PRELIMINARY DRAINAGE REPORT

for
HAVEN VALLEY

EL PASO COUNTY PCD FILE NO. PUDSP-21-007

Drexel, Barrell & Co.

Figure 7-9. Street Capacity Charts Minor Residential (Attached Sidewalk)

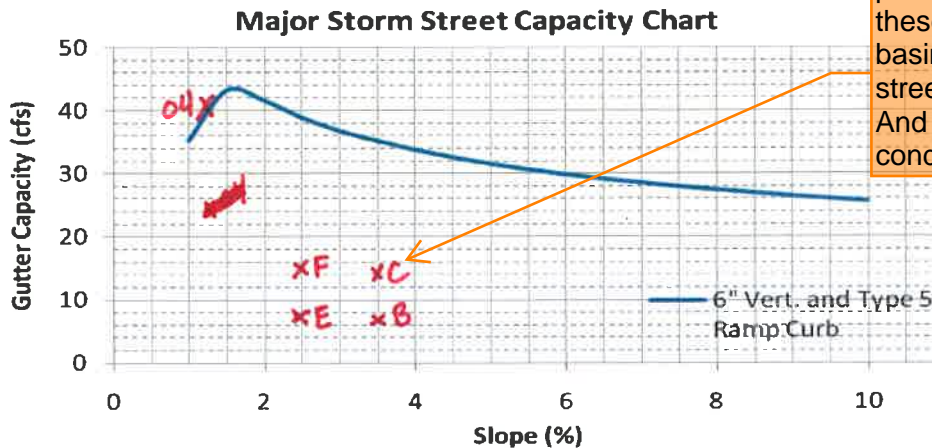
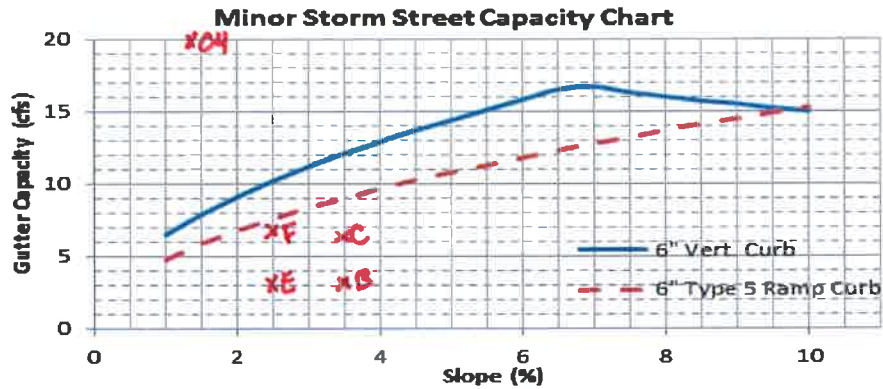
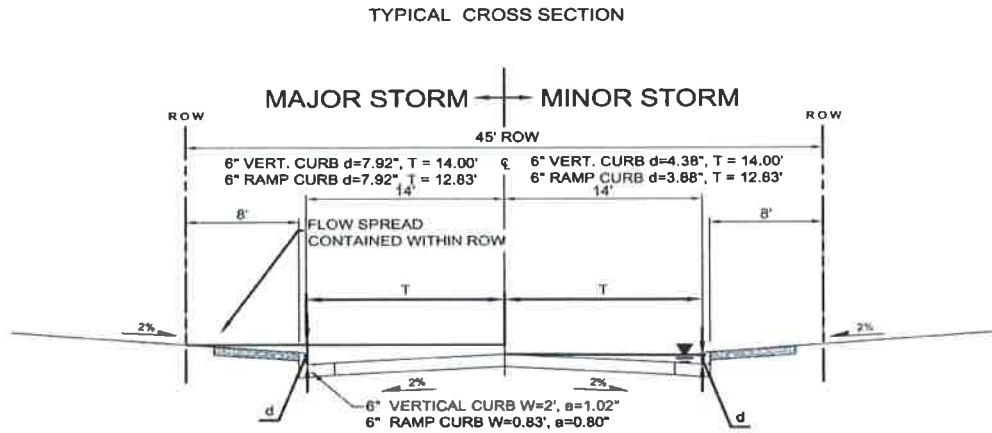
provide key/legend for these. Do they represent basins, DP's, or specific streets? And is this existing conditions or proposed?

EXISTING CONDITIONS
DRAINAGE PLAN

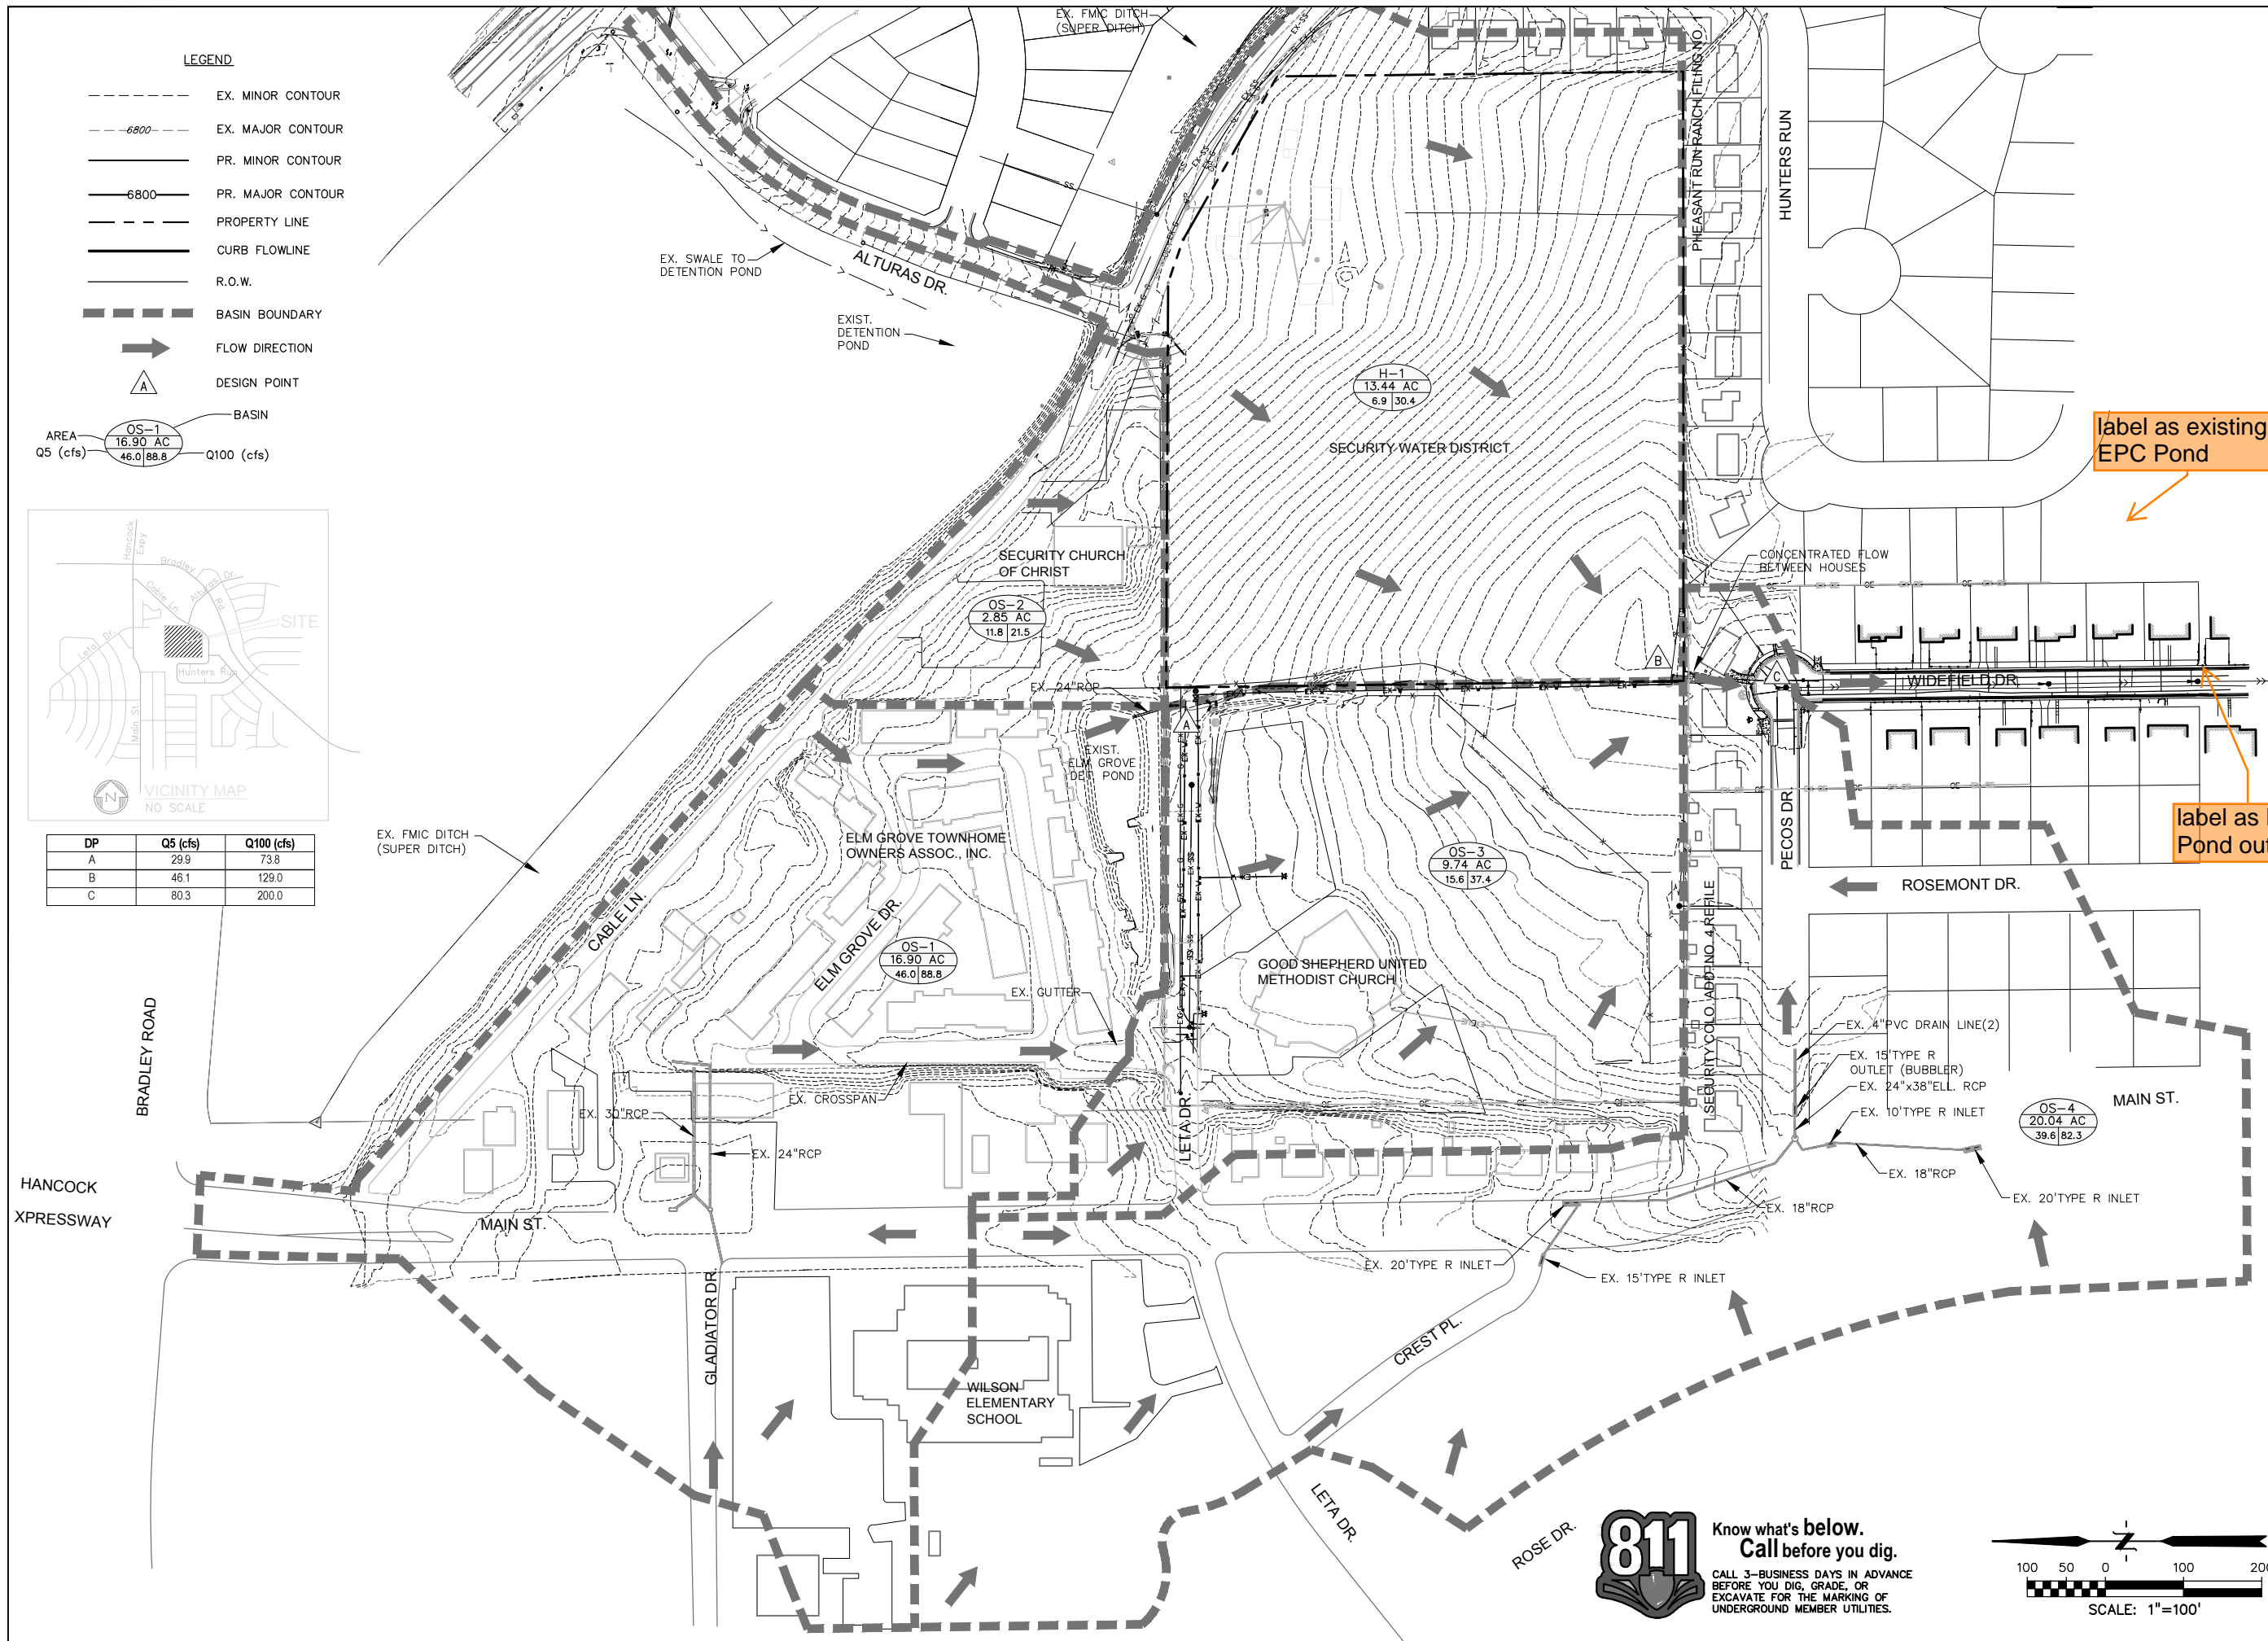
label as existing EPC Pond

label as EPC Pond outfall

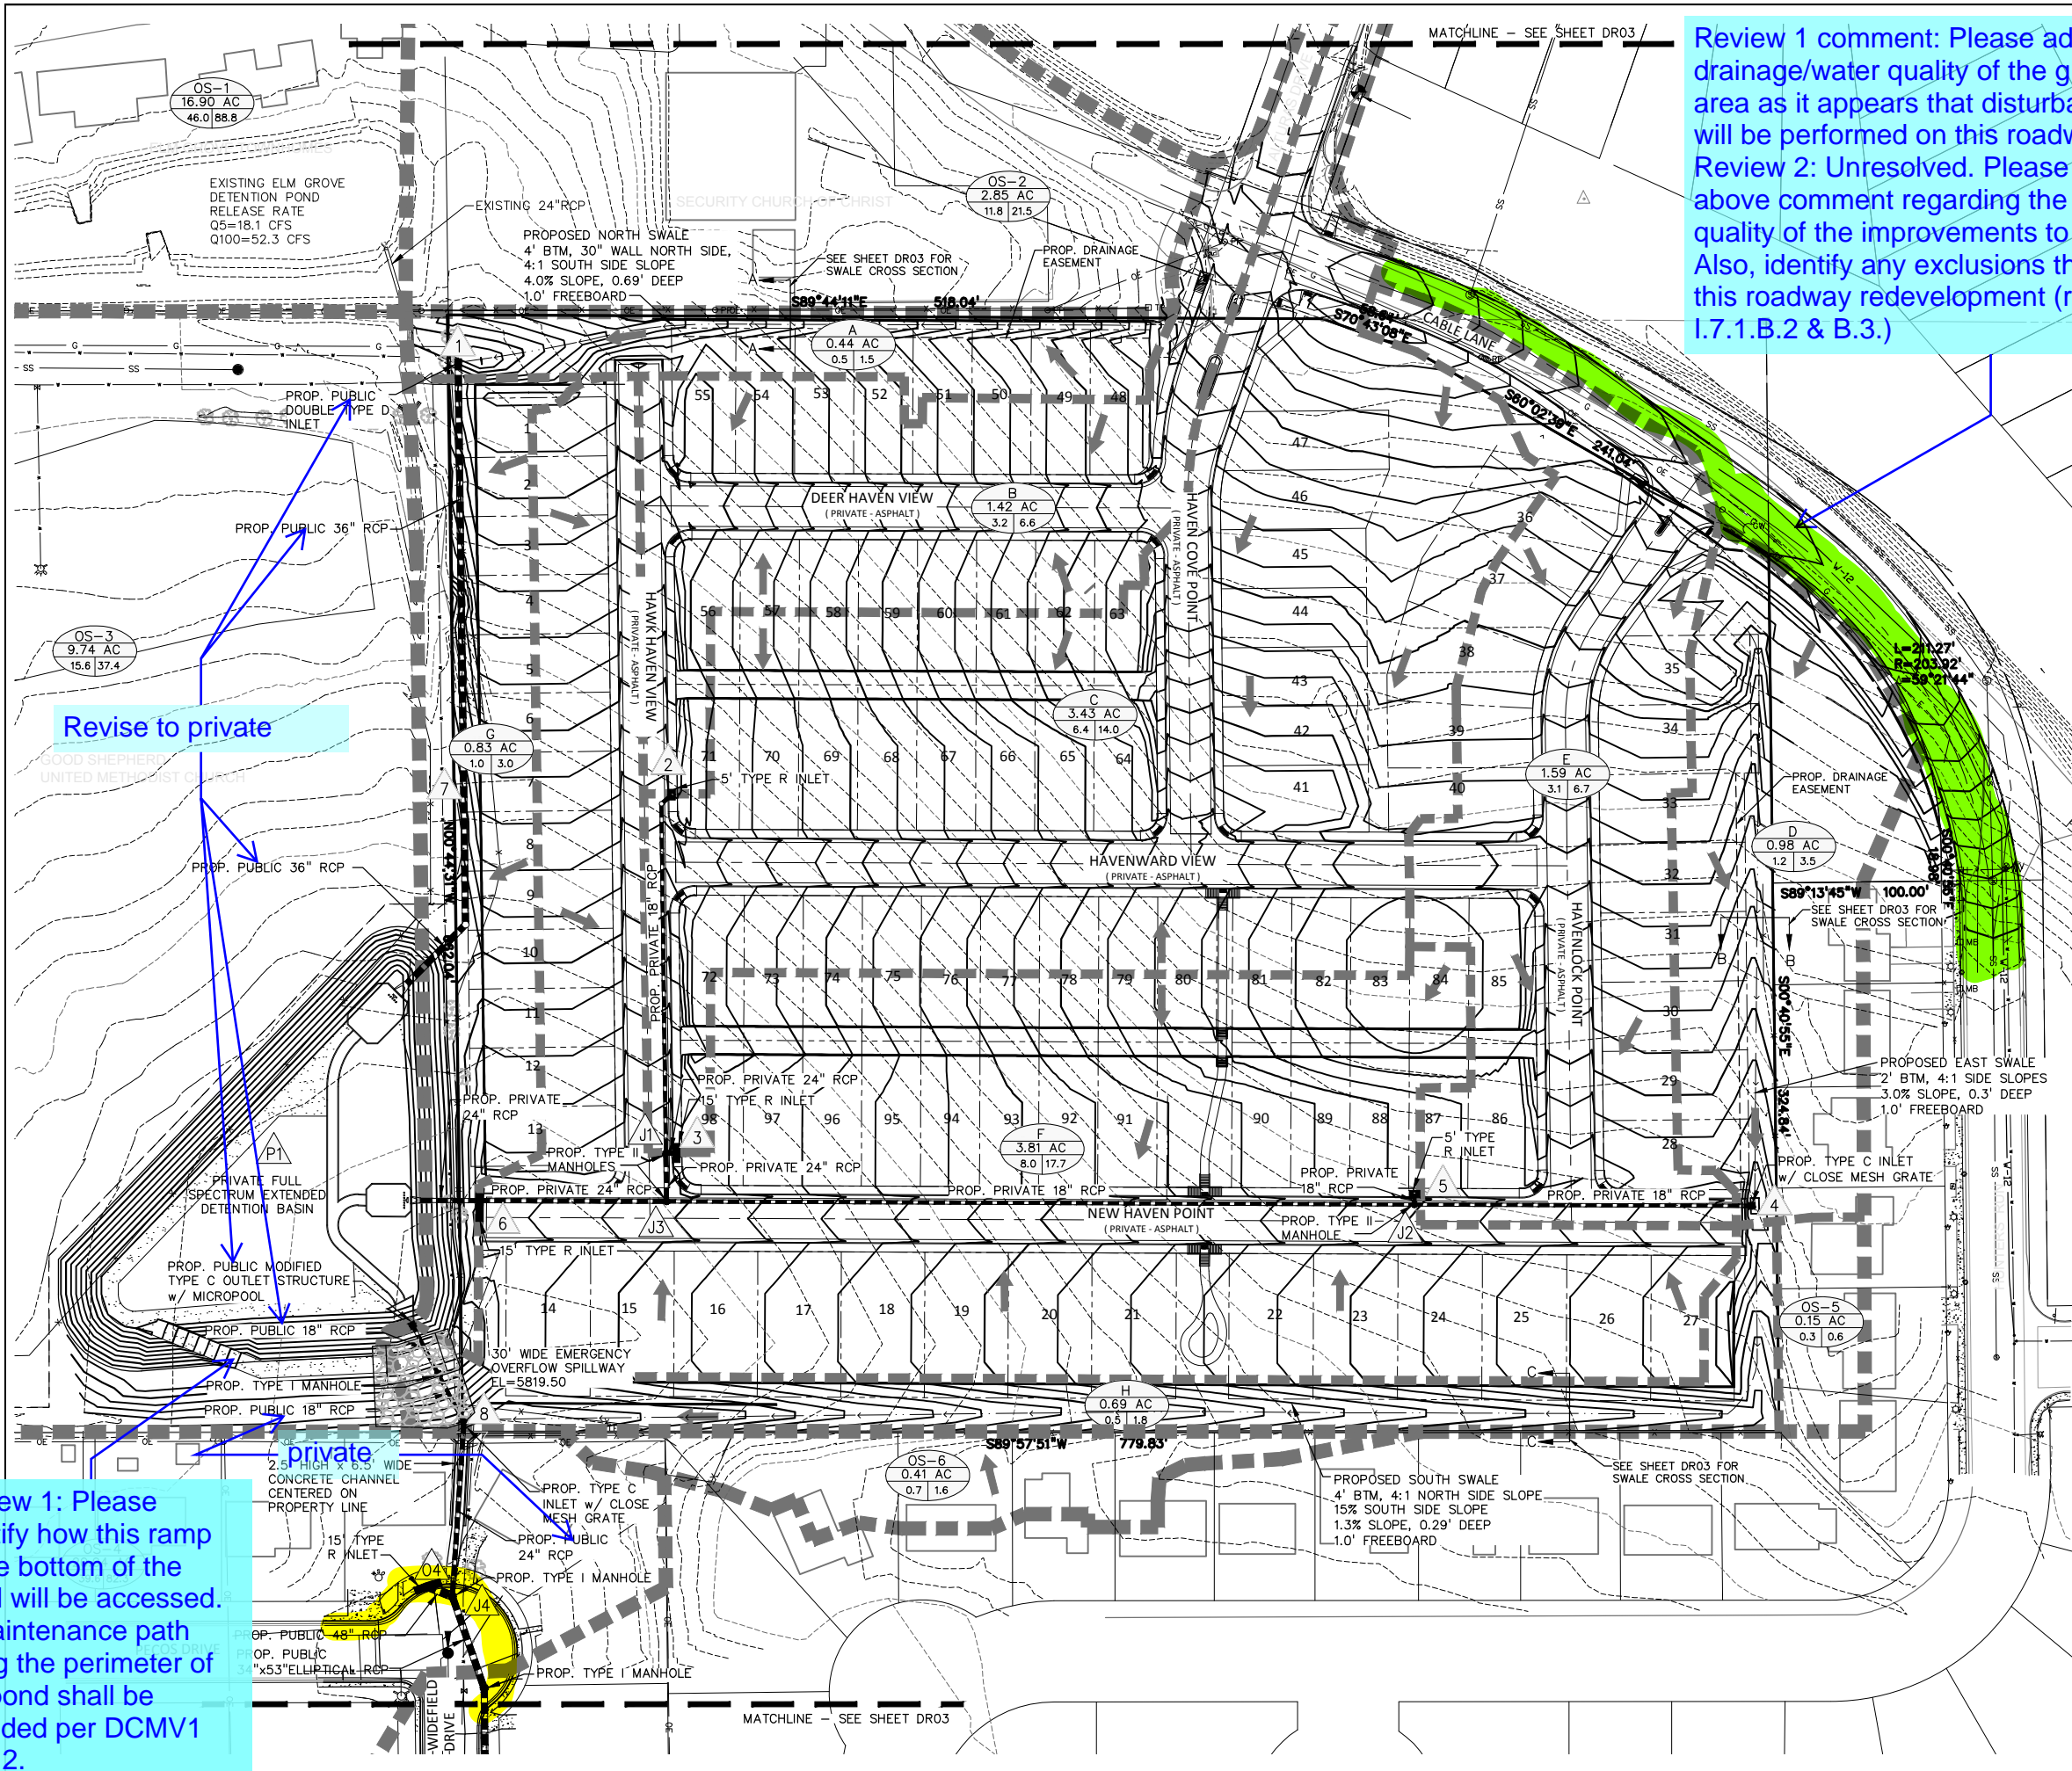
Review 1 comment: Please address the drainage/water quality of the green highlighted area as it appears that disturbance/construction will be performed on this roadway.
 Review 2: Unresolved. Please address the above comment regarding the drainage/water quality of the improvements to Cable Ln.
 Also, identify any exclusions that may apply to this roadway redevelopment (refer to ECM I.7.1.B.2 & B.3.)

Revise to private

Review 1: Please identify how this ramp to the bottom of the pond will be accessed. A maintenance path along the perimeter of the pond shall be provided per DCMV1 11.2.2.
 Review 2: Unresolved.

PROPOSED CONDITIONS
 DRAINAGE PLAN

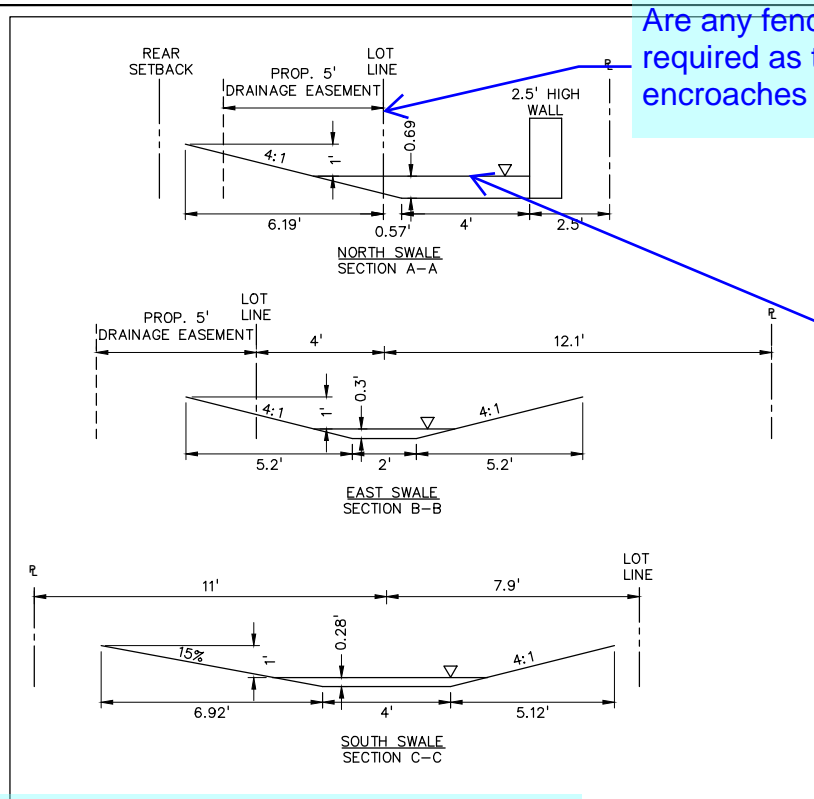
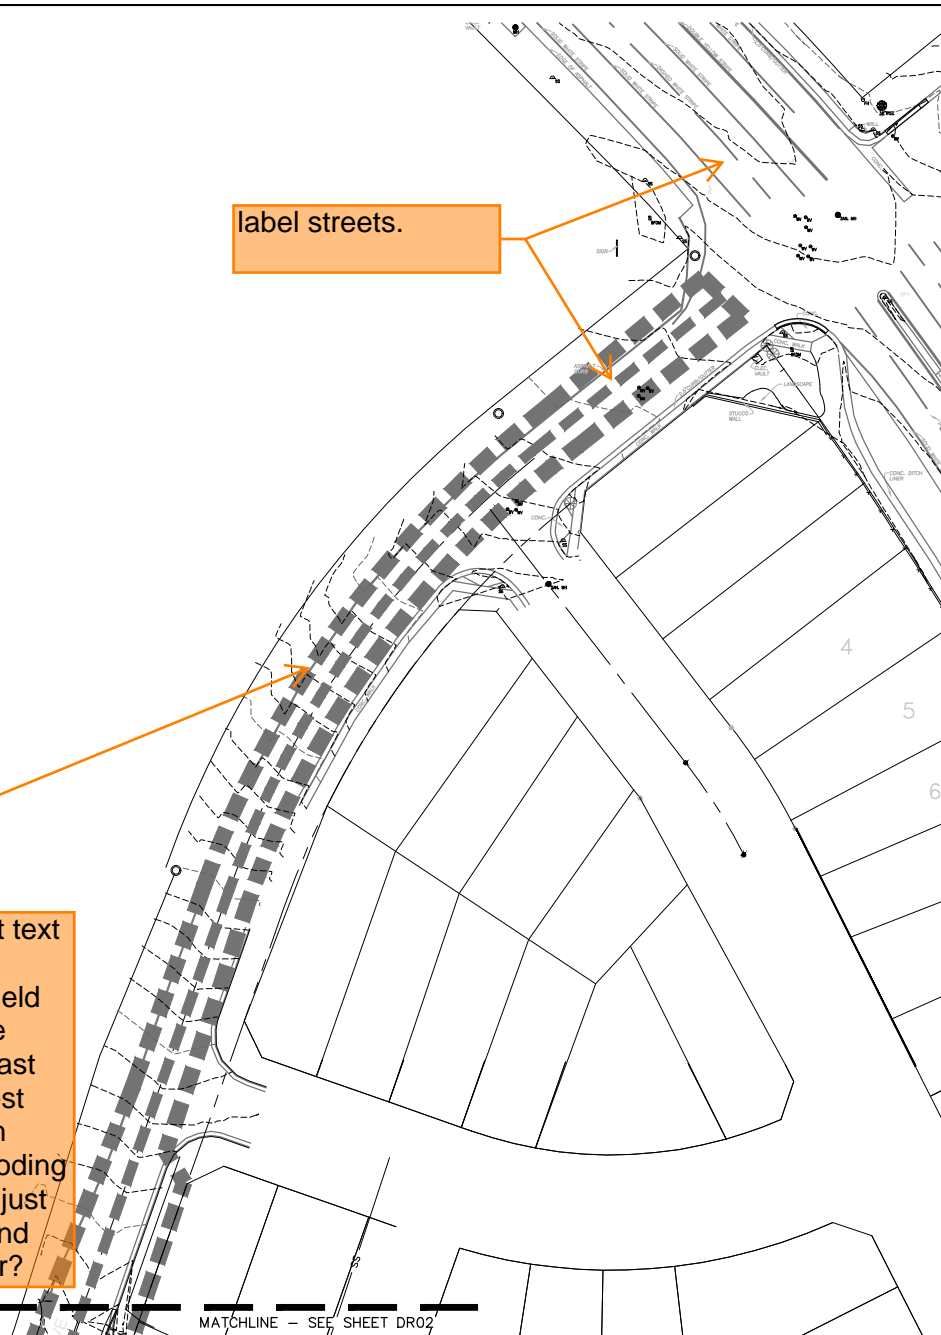
Are any fence restrictions required as the 100yr wse encroaches into the lots?

After discussion with staff (including the County Engineer) there are concerns that the increase in stormwater volume due to this development may further exacerbate the drainage problems downstream of the site. Please analyze to the next man-made outfall which appears to be at the intersection of Main St and Marquette (Please verify).

label basins and show flow arrows

Please also address in the report text the possibility of flooding at the homes on the east side of Widefield Dr, adjacent to the bubbler, since there will be more flows on the east side of the street, than on the west side. Do the homes have enough elevation such that instead of flooding the homes, the excess flows will just overtop the crown of the street and continue down the western gutter?

label street.

Does the outfall from Haven Valley area currently only convey down the east side of Widefield? Because if not, this could effect the outfall of the EPC pond if there is now more water on the east side than before. See my comment in the report above on pages 4 and 5. Discuss in Section 5.0 above.

Show existing outlet from EPC pond and discuss effects of the proposed conditions on this outlet. We do not want the pond backing up. In the report text above, address this potential issue and how impacts have been mitigated. This is part of showing that there is a suitable outfall for this site.

label streets.
